#### HISTORIC AND DESIGN REVIEW COMMISSION

**HDRC CASE NO:** 2021-349

**ADDRESS:** 801 MATAGORDA

**TYPE OF WORK:** Window replacement, fenestration modifications, rear addition removal and

1st Floor

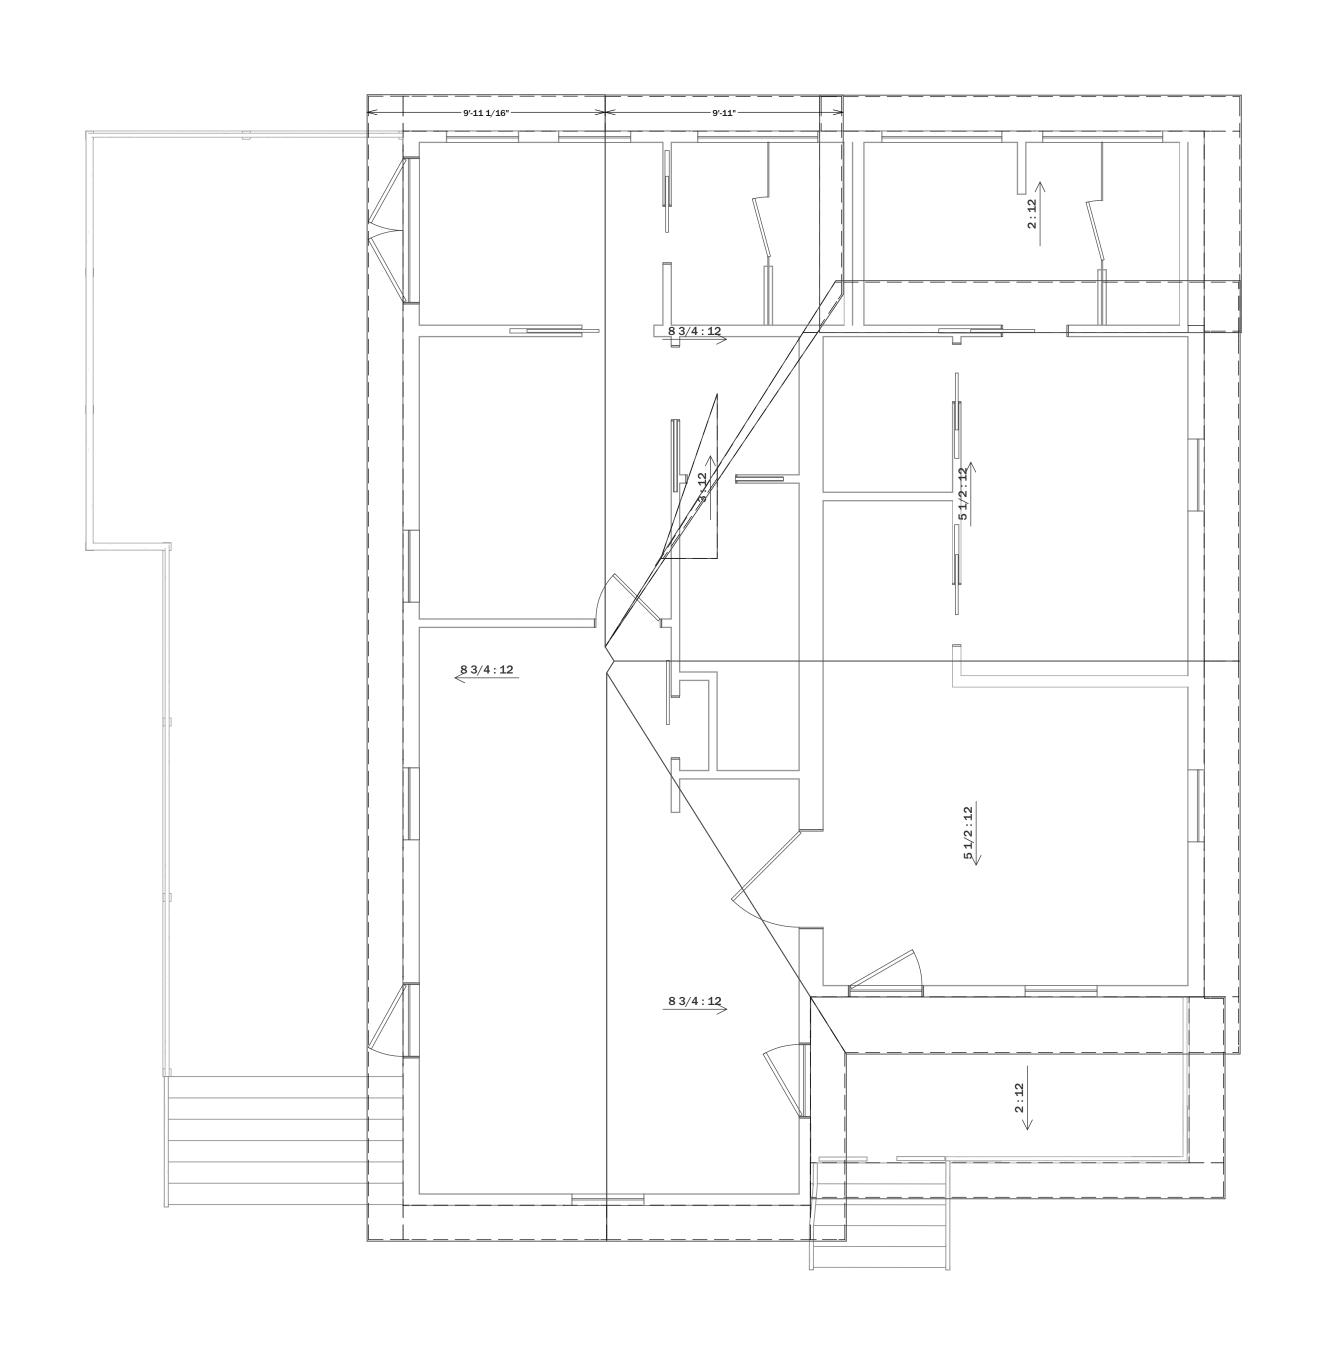
- f. DECK INSTALLATION The applicant has proposed to install a 522-square-foot wood deck on the south (side) elevation. The side deck will feature a front-facing set of 9'-11" wide stairs. Guideline 7.B.iv for Exterior Maintenance and Alterations states that new elements, such as stairs, should be designed to be simple so as to not distract from the historic character of the building. Do not add new elements and details that create a false historic appearance. Staff finds that the applicant should reduce the width of the deck stairs to more closely match the width of the front porch stairs.

- g. REAR ADDITION REMOVAL The applicant has proposed to remove the existing rear addition. According to the 1896, 1904, and 1912 Sanborn Maps, the structure did not feature a rear porch until circa 1912. An open rear porch appears on the 1912 Sanborn Map in the location of the existing rear addition. Staff finds the proposal appropriate.

i. That the applicant reduces the width of the deck stairs to more closely match the width of the front porch stairs or orients the deck stairs to the side of the structure. The applicant is required to submit an updated site plan to staff for review and approval prior to the issuance of a Certificate of Appropriateness.

Item 4, staff recommends approval of the removal of the existing rear addition based on finding g with the following stipulation:

RIGHT ELEVATION

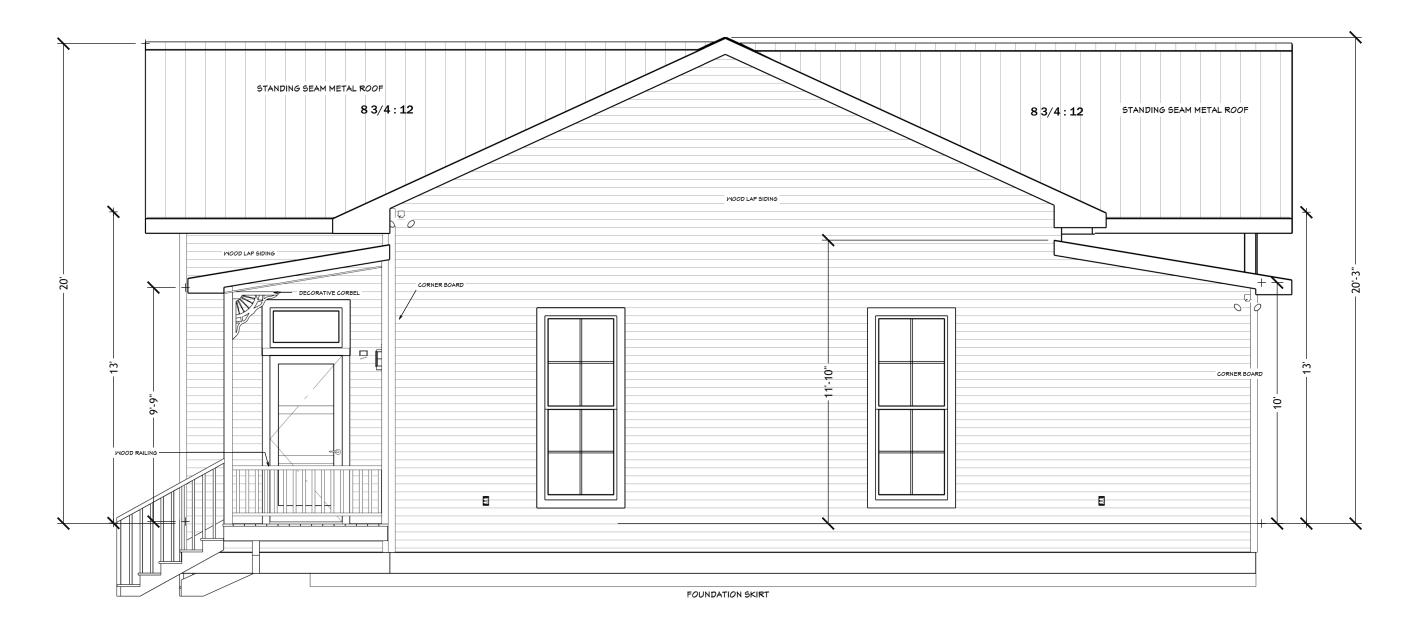
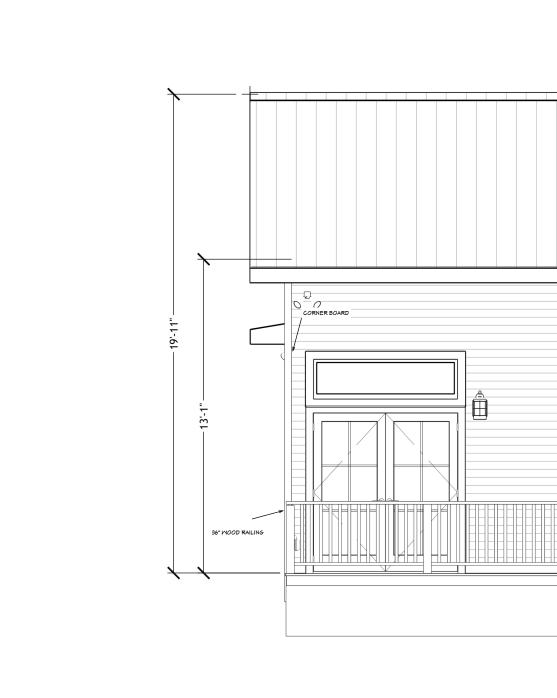
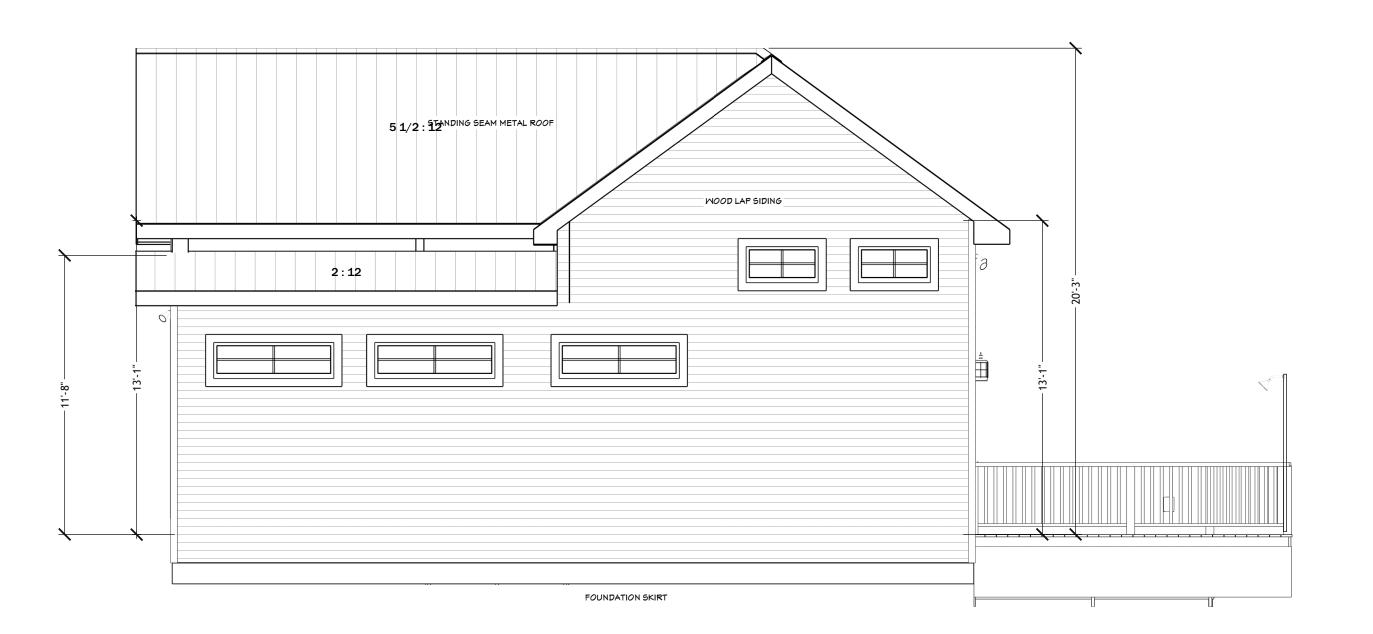
- c. WINDOW REPLACEMENT The applicant has proposed to replace the existing aluminum windows with fully wood Jeld-Wen 2500 windows. The applicant has proposed to restore the window openings to their original size. On the South elevation, the applicant has proposed to restore the original size of the historic openings with the installation of transom windows above the windows and proposed door openings. Guideline 6.B.iv states that new windows should be installed to match the historic or existing windows in terms of size, type, configuration, material, form, appearance, and detail when original windows are deteriorated beyond repair. Staff finds the proposal appropriate and finds that the applicant should install windows the size of the historic openings in lieu of the transom window configuration.

- d. FENESTRATION MODIFICATONS: NORTH ELEVATION The applicant has proposed to remove one window opening on the north elevation. The existing window is located on the existing rear addition which is not original to the structure. Staff finds the proposal appropriate.

- e. FENESTRATION MODIFICATIONS: SOUTH ELEVATION The applicant has proposed to replace the window on the south elevation toward the front façade with a full-lite door and the window on the south elevation of the existing rear addition with a set of French doors. As the existing aluminum windows are not original and the existing rear addition is not original to the structure, staff finds the proposal appropriate.

- m. CHIMNEY REMOVAL The applicant has proposed to remove 3 inoperable chimneys from the primary structure. The Historic Design Guidelines state that existing historic roof vents should be maintained. When deteriorated beyond repair, replace roof vents in-kind or with one similar in design and material to those historically used when in-kind replacement is not possible. The existing chimneys are currently inoperable and do not feature interior fireplaces or stoves but are supported by interior walls. Staff finds the proposal inconsistent with the Guidelines.

Item 2, staff recommends approval of the proposed fenestration modifications based on findings d through e with the following stipulation:
